**Report: Punch list**  
**Function: Test, Adjust, & Balance**  
**Date: 11/05/2025**  
**Completed By: National TAB**

## 11-03-25 Fredmys - Versailles, KY

Project: 11-03-25 Freddys - Versailles, KY

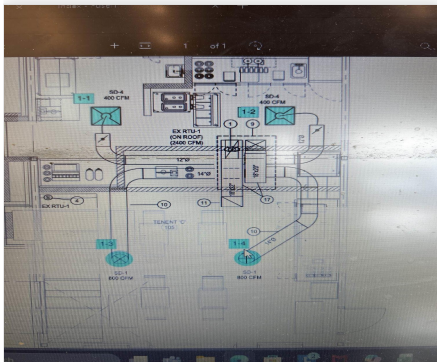
**Issue Name :** Hood HMI not functioning properly  
**Description :** HMI controls both hoods with a single speed. They cannot be controlled independently of each hood.  
**Created By :** National TAB                      **Assigned To :** National TAB - Dan Hertenstein  
**Status :** Open  
**Priority :** High                                      **Asset Tag :** HVAC EQUIPMENT1  
**Originated Date :** 11/05/2025 - Jearod Ferrette - National TAB
